ADDENDUM NO. 1

DATE: October 24, 2012

SUBJECT: COUNTY PROJ. NO: 5-41
 STATE PROJECT NO: 019-605-028, 179-020-031, 1901-148
 MINN. PROJECT NO: HPPH-STP09-STP 1912(258)
 LOCATION: TH 13/CSAH 5 Interchange Burnsville
Addendum No. 1
 Date of Letting 9:00 a.m. October 30, 2012

CITY OF BURNSVILLE - ENGINEERING DEPT.
WATERMAIN BLOCKING

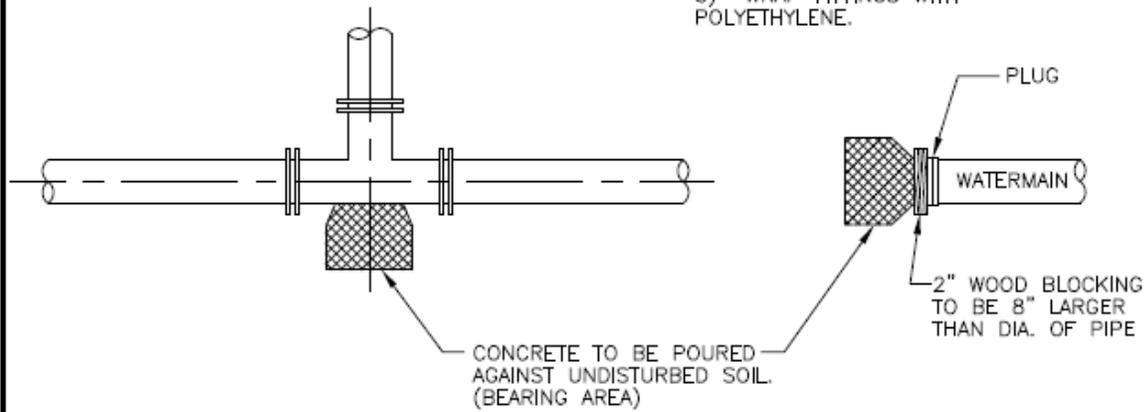
Insert the following paragraph and table between the second and third paragraphs of this section. Also include the attached Watermain Blocking detail that is referenced in 2611.3 A4.

The below table shall serve as the required restrained joint distances from any direction of the type of fitting that may be encountered during the construction of the watermain distribution system. There is no additional compensation for providing the restrained joints necessary and shall be considered incidental to the cost of the fittings per section 2611.4 I. These restrained joints may be provided by retainer glands as specified in section 2611.2. Additional reaction backing may be required by the Engineer at no cost to the Owner, but no further joint restraint shall be required. Where specified below as “Reaction Blocking”, the contractor can achieve thrust restraint at the fitting by providing reaction blocking, but does not prohibit the use of retainer glands.

SP
 1901-148
 019-605-028
 179-020-031
 Sheet No.
 U2 of U28

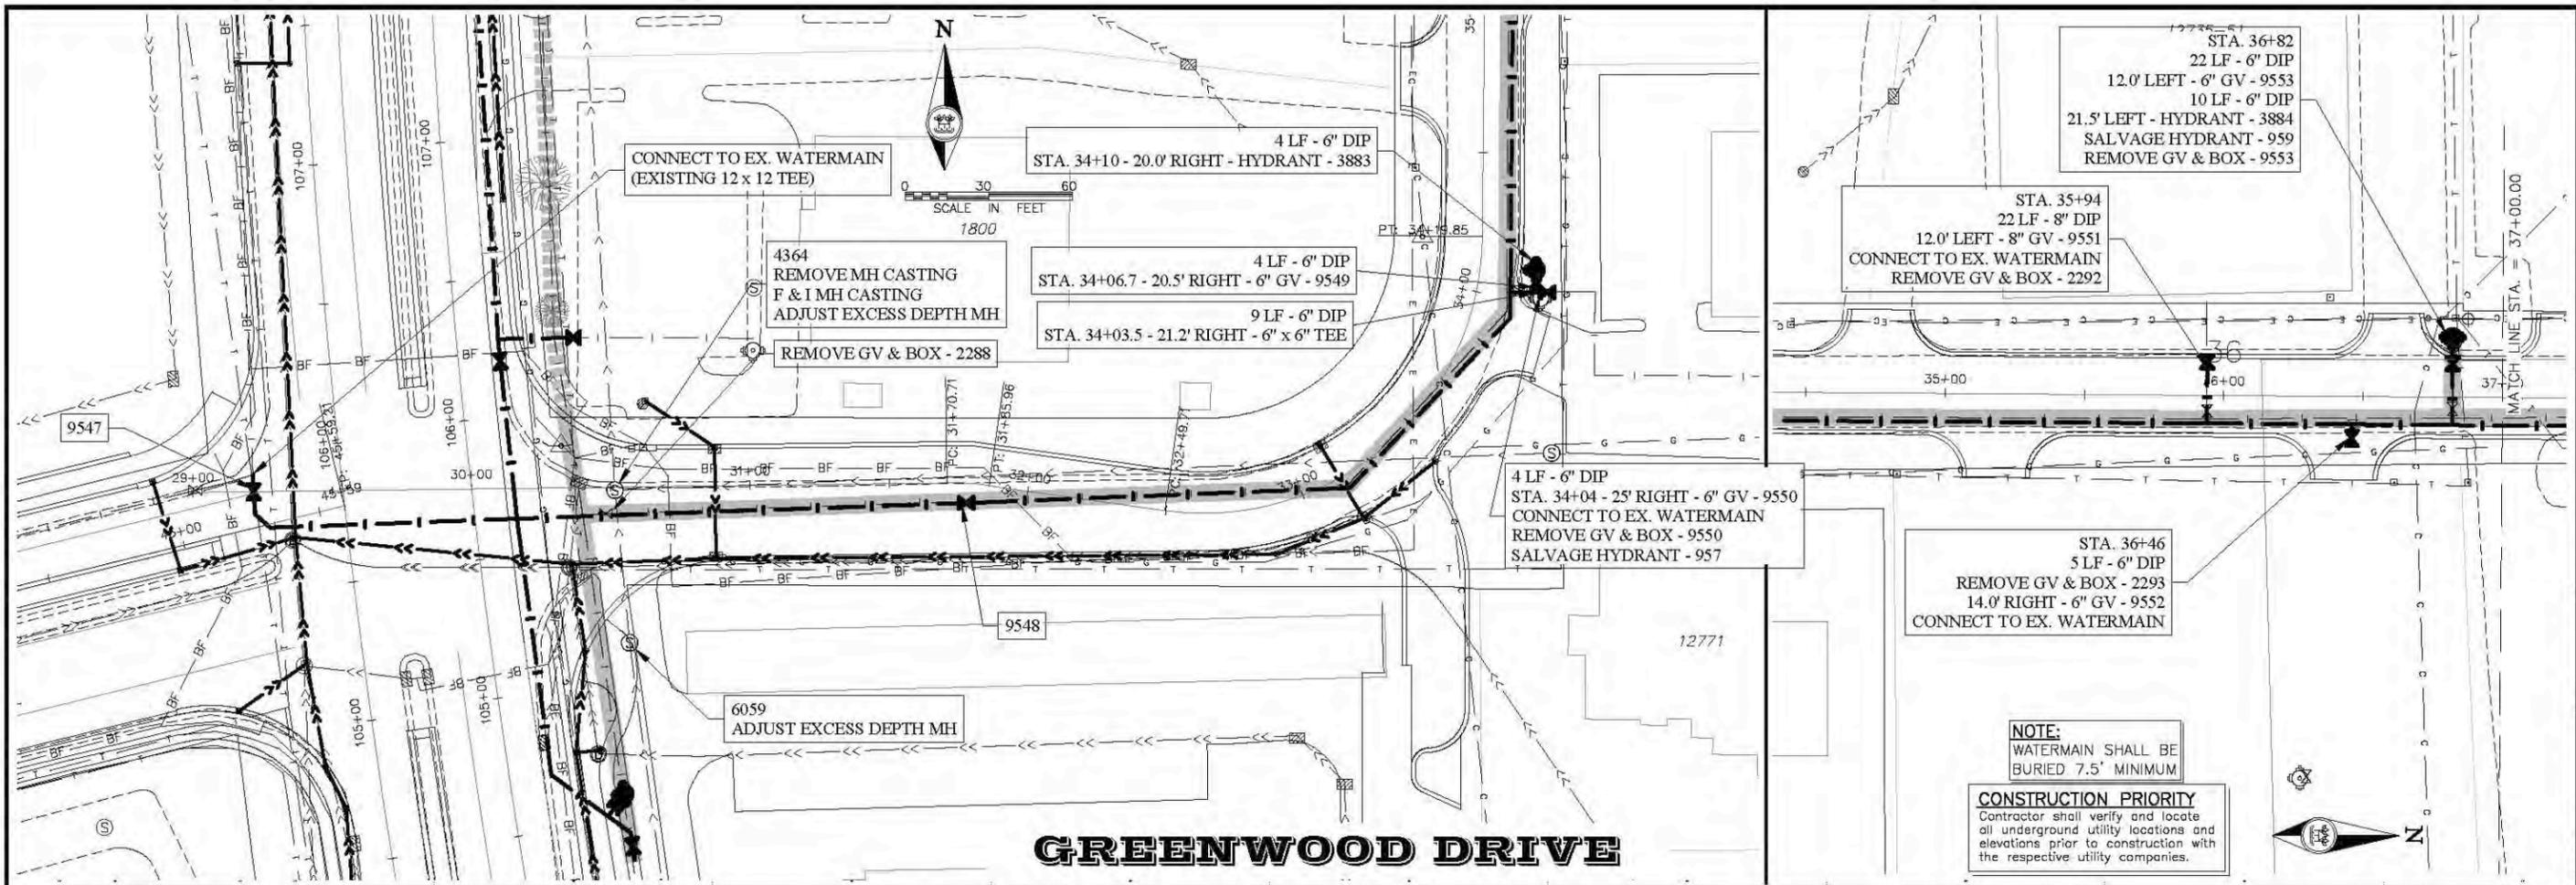
- a. Sheet U2 Identifies the 2503 6” & 8” PVC PIPE SEWER as **SDR 26** and 2503 8”, 10”, 12”, & 16” DUCTILE IRON PIPE SEWER as **CL 52**.
- b. Sheets U6, U9, U10, & U23 modifies the watermain vertically to provide a minimum vertical separation of 18 inches on all watermain from storm sewer and sanitary sewer crossings.
- c. Sheets U7, U11, U23 modify the locations of several hydrants to meet the standard that all hydrants must be 10’ away from sanitary sewer or storm sewer facilities.
 - i. Sheet U6: At station 29+36 the 16” DIP was raised at 84” RCP crossing and at station 33+30 the 16” DIP was raised at Sanitary Sewer crossing
 - ii. Sheet U7 Moved Hydrant 3885 8’ RT at 43+28
 - iii. Sheet U9 & U10: 8” DIP was lowered to go under 8” PVC crossing at station 52+74

UTILITY PLAN & PROFILE
SOUTHEAST FRONTAGE ROAD
from Sta. 61+00 to Sta. 69+00

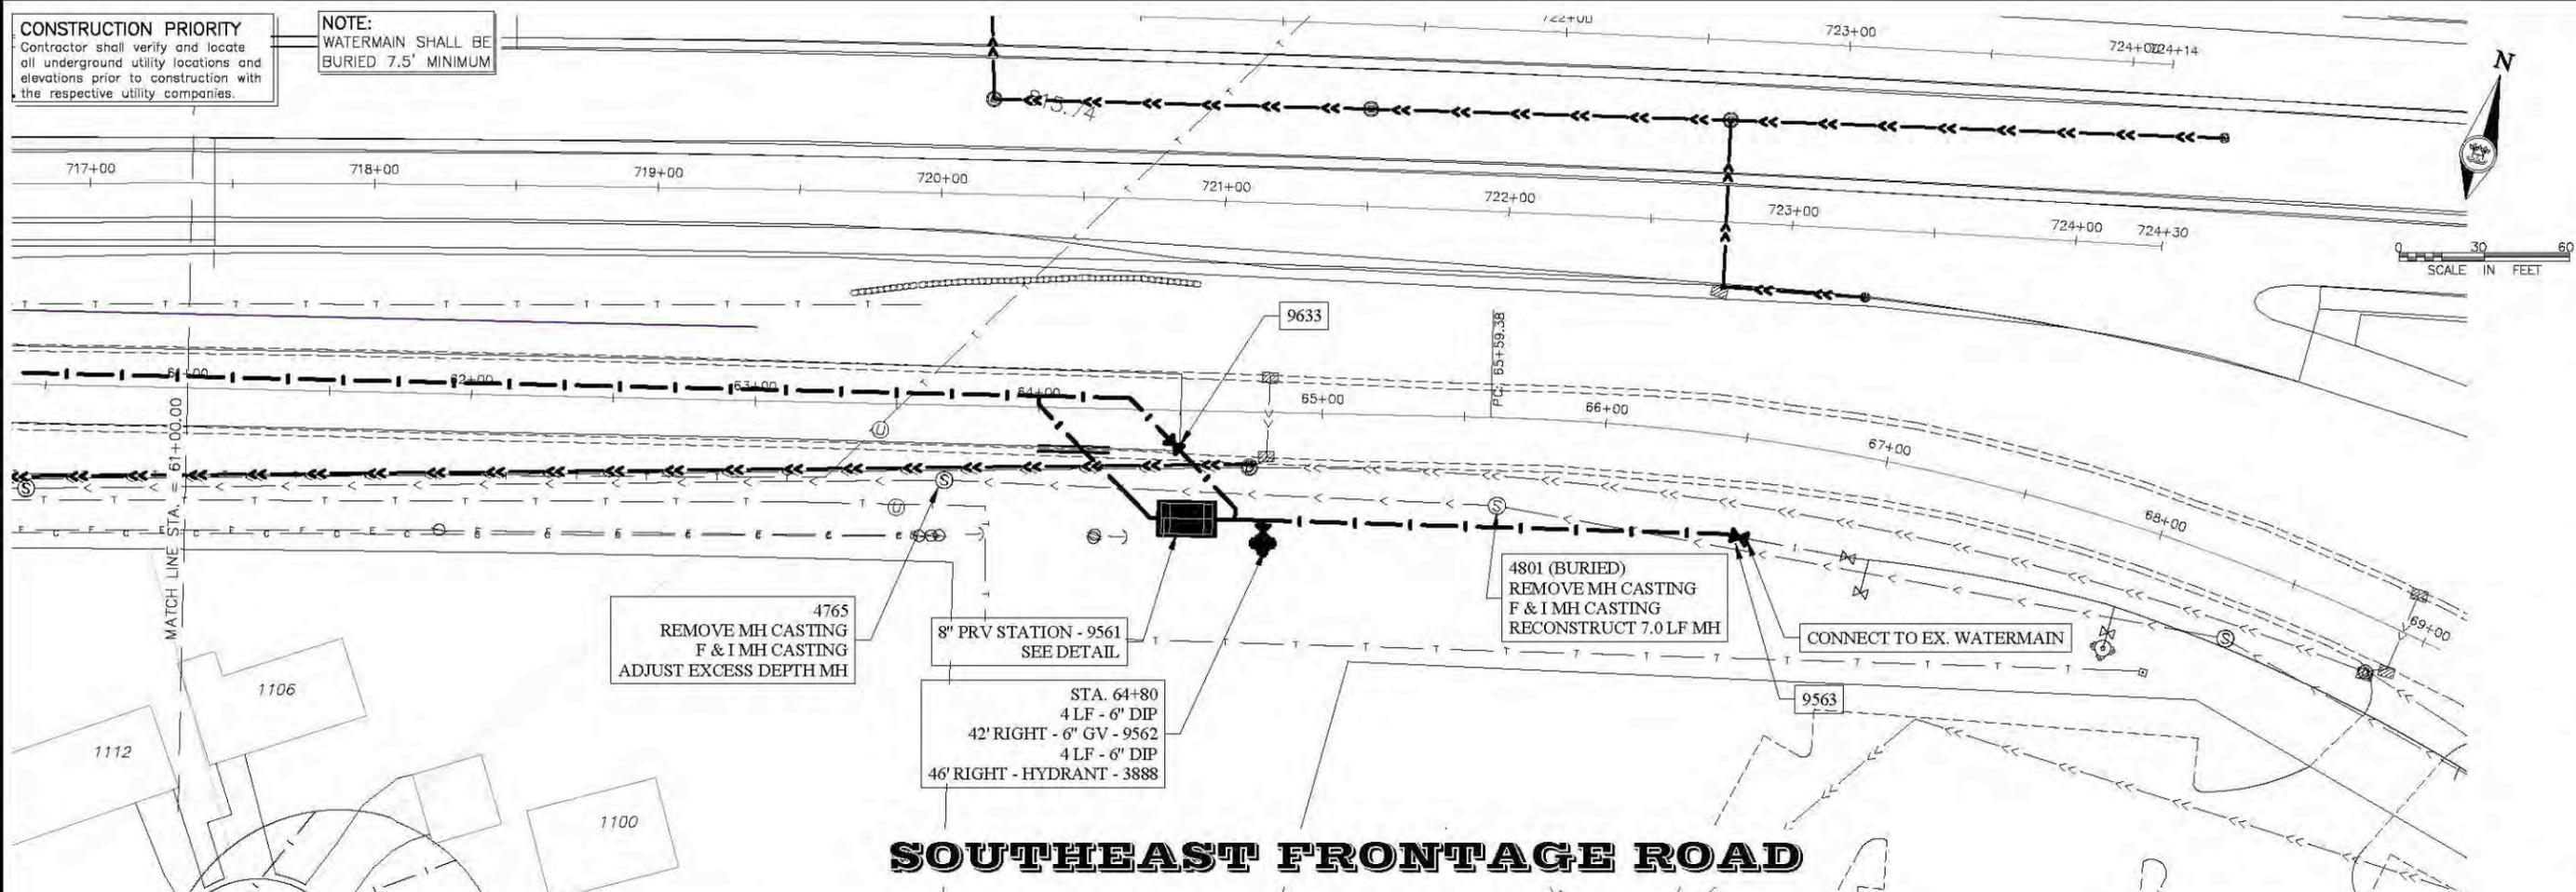
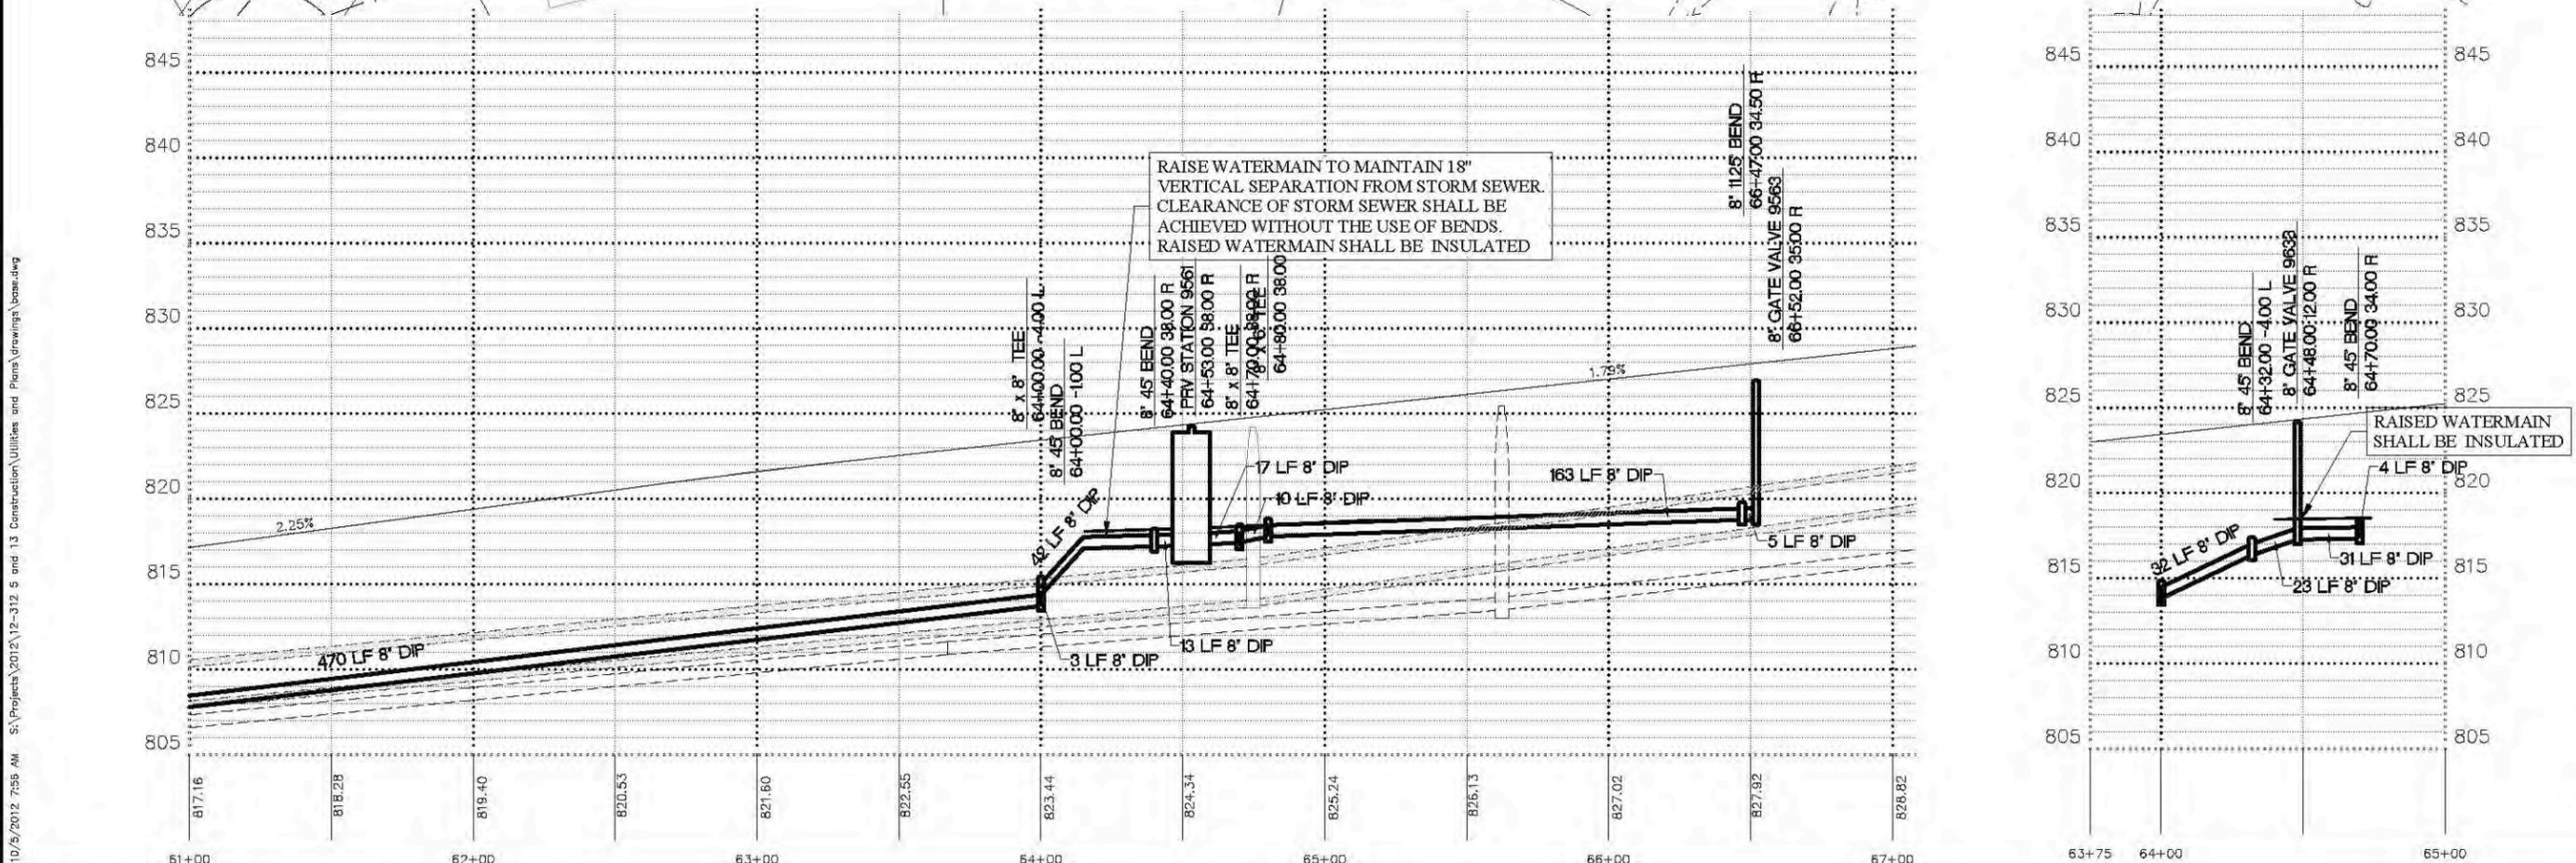
- iv. Sheet U11 Moved Hydrant 3888 to 64+80
- v. Sheet U21 Moved Hydrant 3882 to 15.5' LT
- vi. Sheet U23 Rotated Hydrant 9897 from west to east and lowered 12" DIP at 21" RCP storm crossing.

DES: G.B.B. DR: N.A. APPROVED: 10/9/12
 CHK: P.D.G. CHK: T.R.S. SHEET NO. 2R OF 91 SHEETS

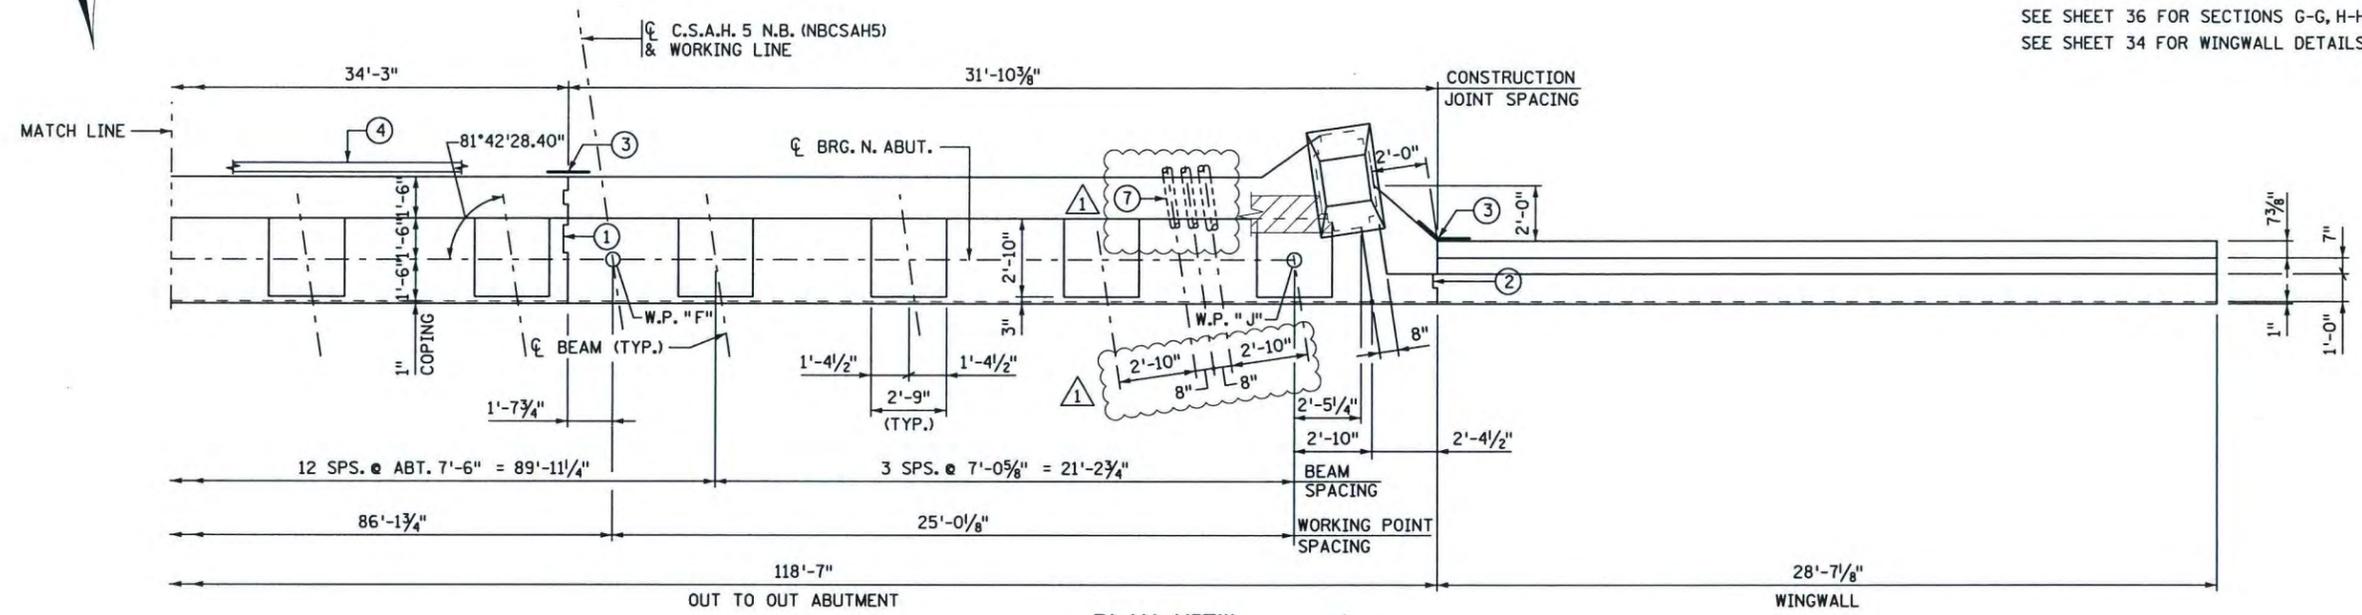
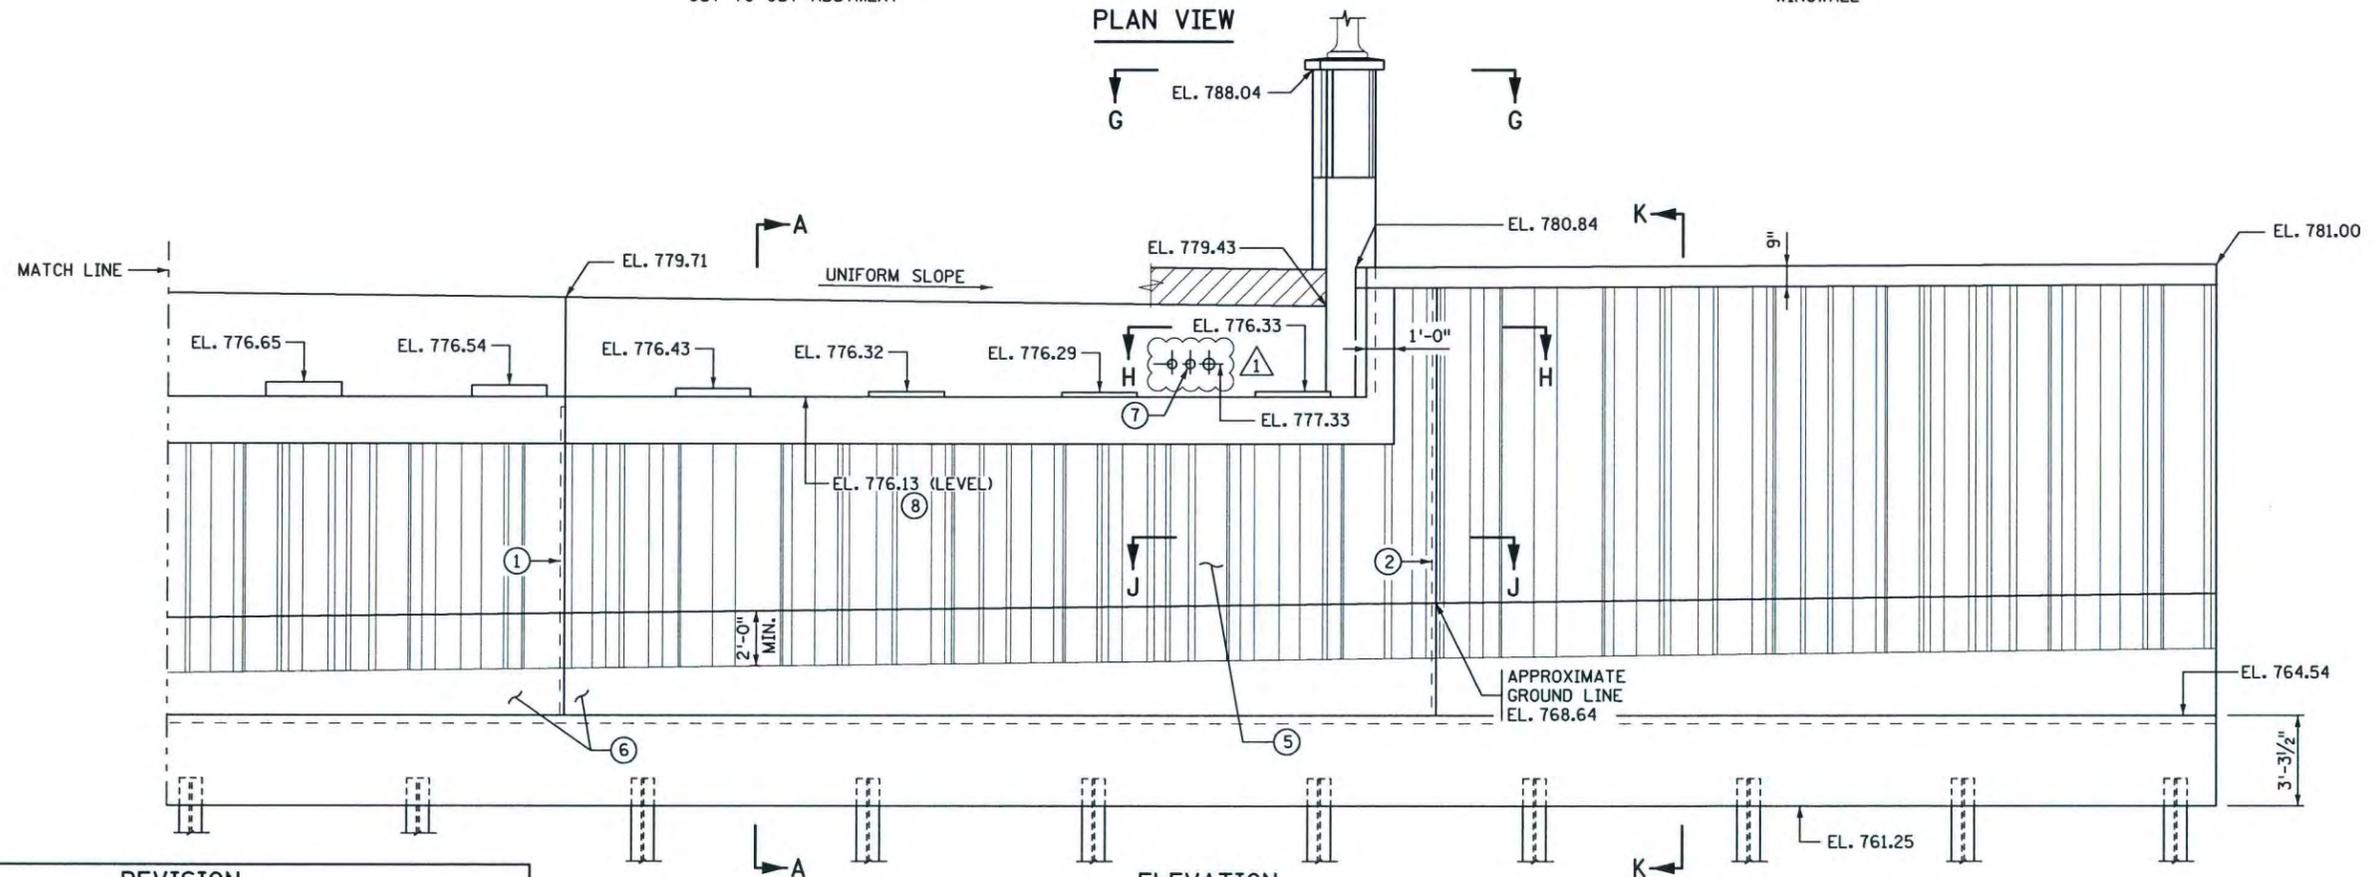
- A. On Sheet 2R of 91 for Bridge No. 19036 the following changes were made:
 - a. The number and configuration of suspended conduits on right side of the "Transverse Section" were modified, as well as circle note 3.
